**RE: Proposed Townhouse Development, 1015, 1025 & 1029 Davis Drive & 22 Hamilton Drive, Town of Newmarket
Site Plan Application**

This memo provides a summary of the changes to this current Site Plan Application, a review of the parking requirements and provisions, and a response to the remaining transportation related comments. The current submission features the same number and types of dwelling, therefore, the findings presented within the previously submitted Updated Traffic Impact Analysis and Transportation Demand Management Strategy remain appropriate and valid.

TCP-1

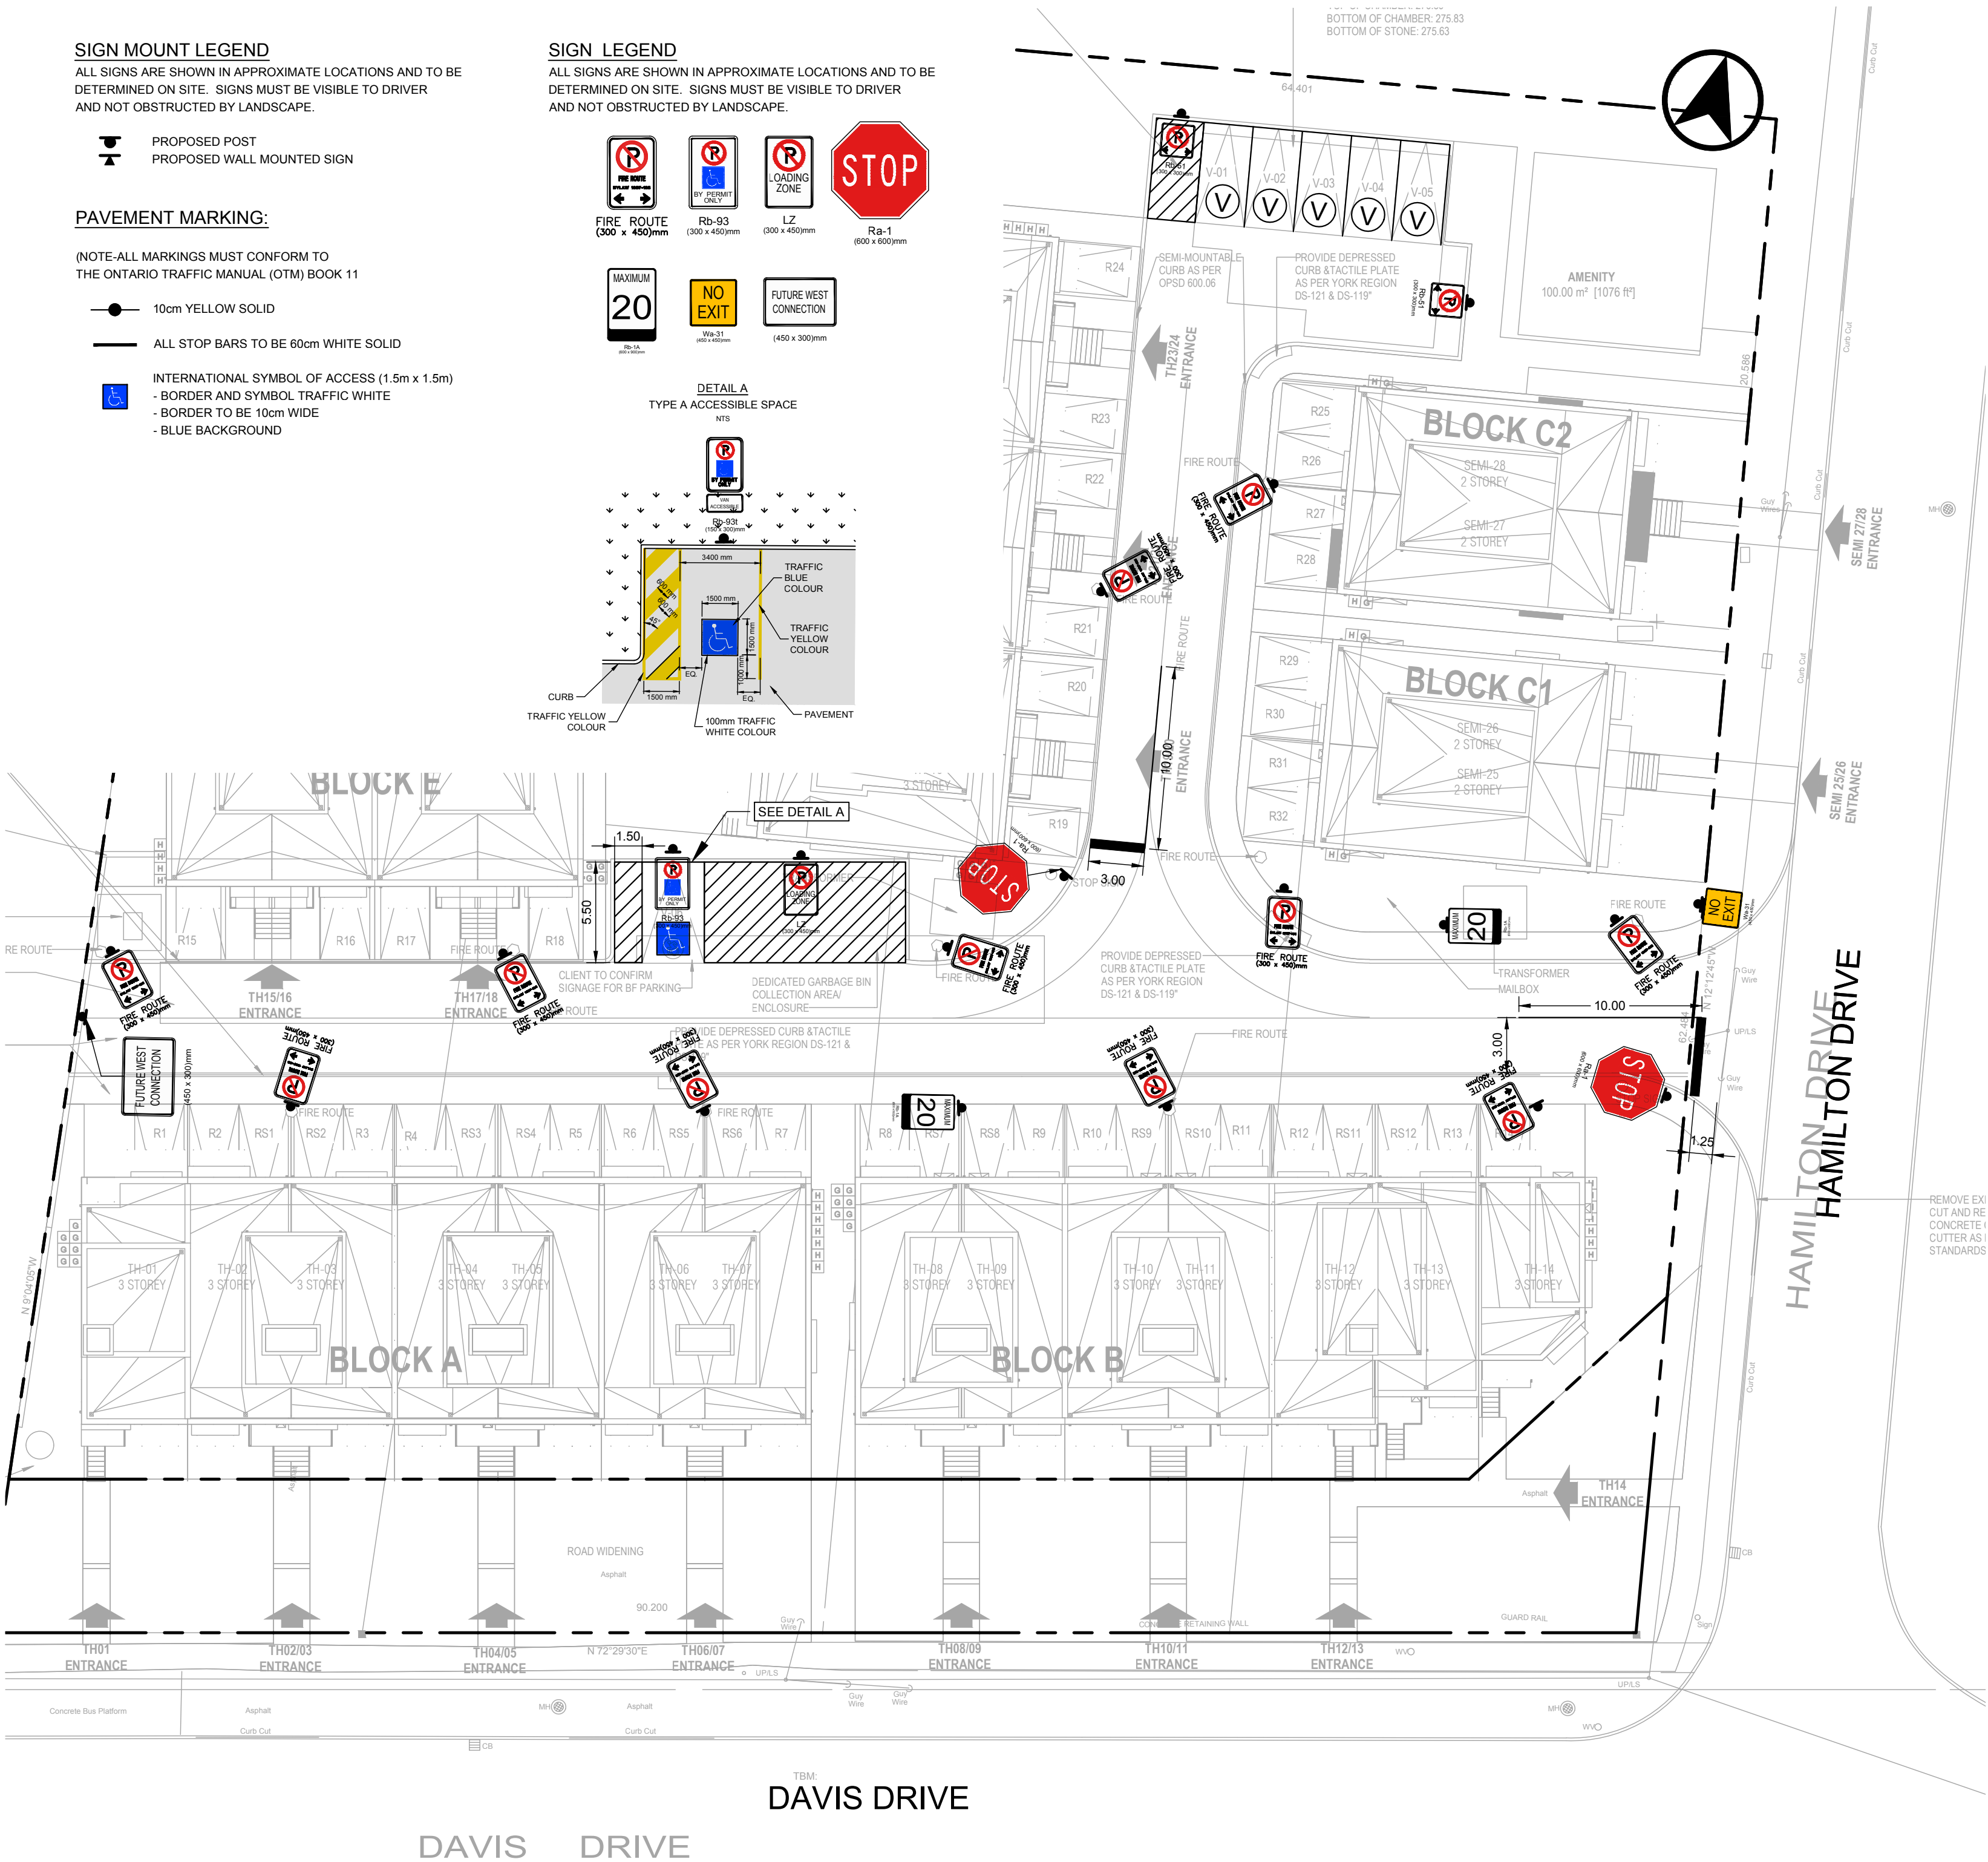
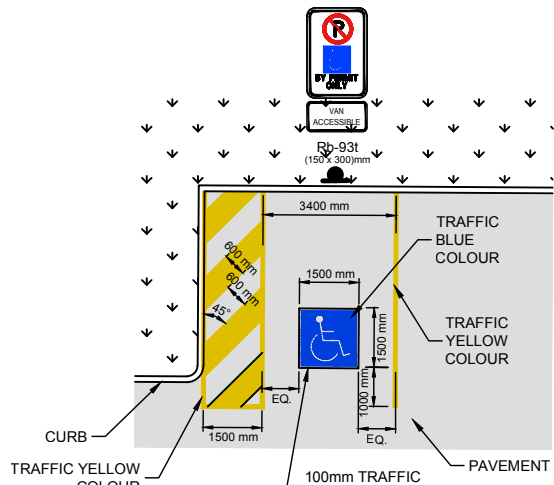
The Town of Newmarket, Planning and Building Services Comments dated December 23, 2022, noted that the site's accessible visitor parking space should be connected to an internal sidewalk. However, the site plan proposes an accessible visitor parking space in a centralized location, in an effort to provide an accessible parking space close to the maximum possible number of homes, and in this case, the centralized location is

not adjacent to an internal sidewalk. Through an email exchange with Town Planning staff, it was confirmed that in the context of the proposed site, the location of the accessible parking space is acceptable and should not be relocated in order to be next to an internal sidewalk. The email correspondence with Town Planning staff is attached in **Appendix C**.

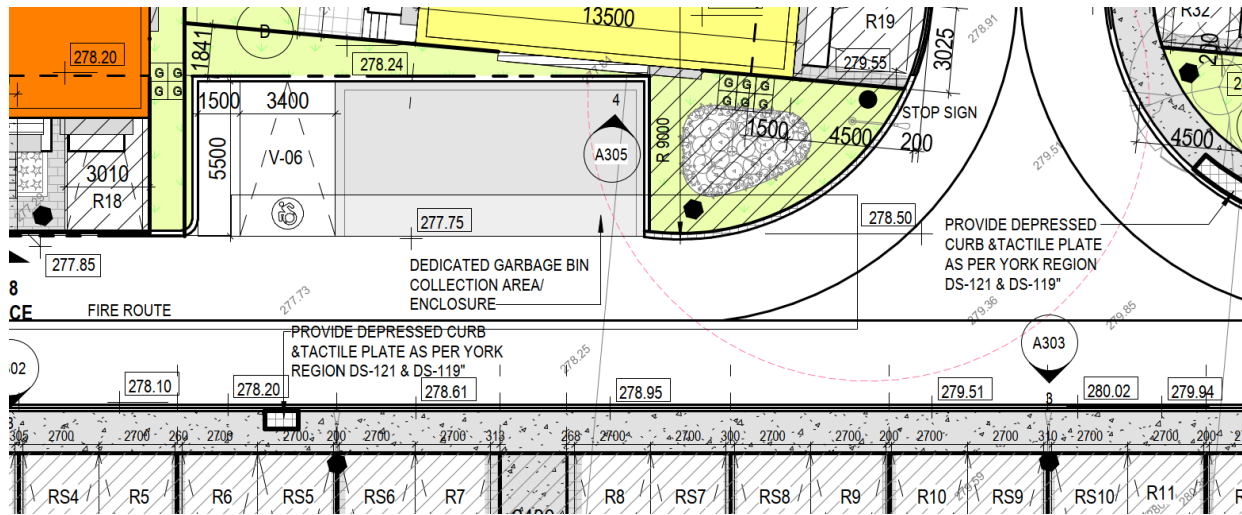
- *“Include accessible parking space length and dimensions for 1.5-metre access aisle on the site plan drawing. The accessible parking space should be connected to an internal sidewalk. Include location of accessible parking sign on Site Plan drawing.”*

How would City Staff like us to address this comment? The Visitor Parking is located centrally to the site and has the required 1.5 m aisle. *See the small snippet image I have included for a better understanding/context.* The sidewalk itself is not located immediately adjacent, but rather located across the street per the image below. **Is staff satisfied with the existing condition that has been illustrated on the Site Plan?**

1. We discussed with the Transportation consultant to provide a “Watch for Pedestrians” sign – OR;
2. Move the accessible space to the Visitor Parking Area to the north so that it can be adjacent to a walkway.

Ideally the accessible space would be connected to a sidewalk in front of the parking area. However, as that condition would not be feasible in this location, the accessible parking space should remain centrally located as shown below.

Please ensure the location of the accessible sign post is shown on the site plan and the sign detail is included on the details page. The access aisle must be demarcated with high tonal contrast diagonal lines.
